Notice Regarding Design Changes of Rear Cases.

Type	Model
Magnetic Contactors	S-T21, S-2XT21, S-T25, S-2XT25, B-T21
Mechanically Latched Magnetic Contactors	SL-T21, SL-2XT21, SLD-T21, SLD-2XT21
Open type Magnetic Starters	MS-T21, MS-2XT21
Enclosed Magnetic Starters	MSO-T21, MSO-2XT21, MSO-T25, MSO-2XT25
Mechanically Latched Enclosed Magnetic Starters	MSOL-T21, MSOL-2XT21, MSOLD-T21, MSOLD-2XT21

Fig1: Product Appearance (S-T21)

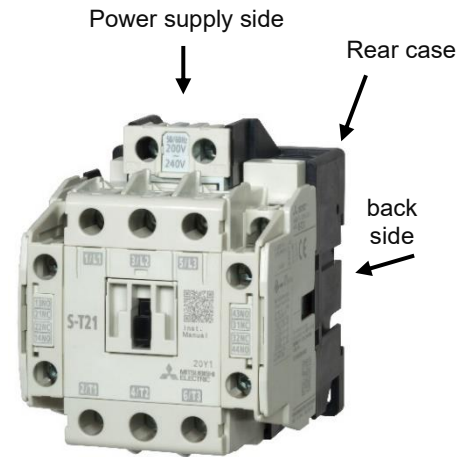
Design changes of IEC 35mm rail mounting section of back side (No.1) and rib shape position of power supply side (No.2)

No.	Before	After
1		
2
